Addendum No. 3
September 28, 2018

Project: **Trinity Reformed Church Addition**
Sioux Falls, South Dakota
Project No.: 2553

Architect: Architecture Incorporated

17) DRAWING SHEET 9.31 – FLOOR PLANS – POWER & SIGNAL

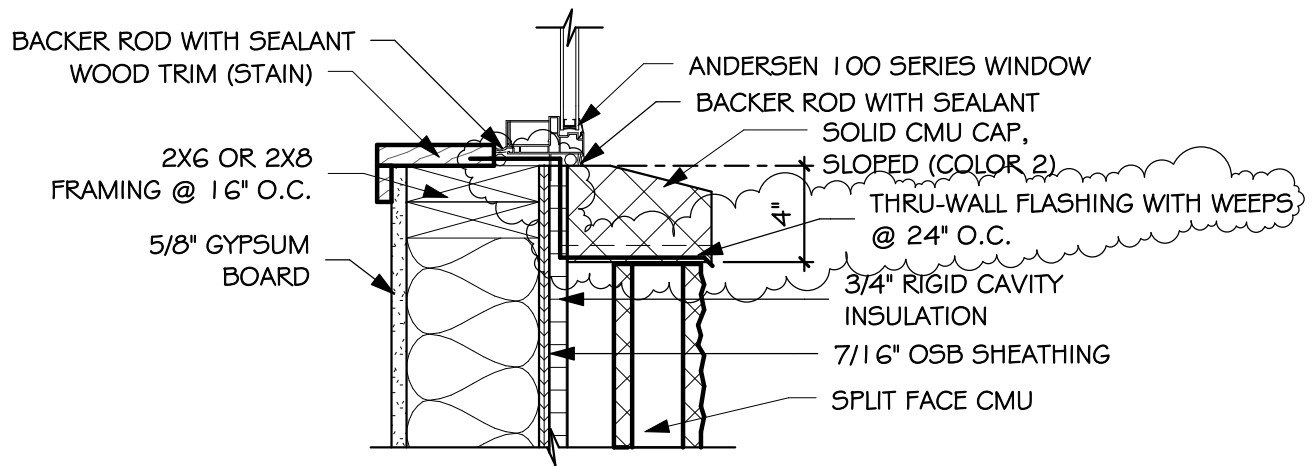
- a) Base Bid Floor Plan – Power & Signal.
 - i) Narthex 101. Reference wall cabinet near main entrance doors labeled “FACP”. Change “FACP” to read “RELOCATED FA ANNUNCIATOR PANEL”.

- ii) Exterior. Reference ground mounted rooftop units RTU-1 and RTU-2 located on the north side of the building. Delete the duct type smoke detectors designated with keynote reference “8” (a total of two). Per the exception to Paragraph 606.2 of the IMC (International Mechanical Code), 2012 Edition, these detectors are not required.

- b) Alternate Vestibule Plan – Power & Signal.
 - i) Vestibule 100. Reference wall cabinet on east wall labeled “FACP”. Change “FACP” to read “RELOCATED FA ANNUNCIATOR PANEL”.

- c) Electrical Notes:
 - i) Note 8: Change this note to read: “NOT USED”.
 - ii) Note 11: Add the following to the end of this note: “IF DEVICE IS EXISTING AND IS COMPATIBLE WITH THE EXISTING SYSTEM, MEETS CURRENT NATIONAL AND LOCAL CODES AND IS IN GOOD WORKING ORDER, IT MAY BE REUSED IN LIEU OF BEING REPLACED.”

- iii) Note 12: Add the following to the end of this note: “IF DEVICE IS EXISTING AND IS COMPATIBLE WITH THE EXISTING SYSTEM, MEETS CURRENT NATIONAL AND LOCAL CODES AND IS IN GOOD WORKING ORDER, IT MAY BE REUSED IN LIEU OF BEING REPLACED.”
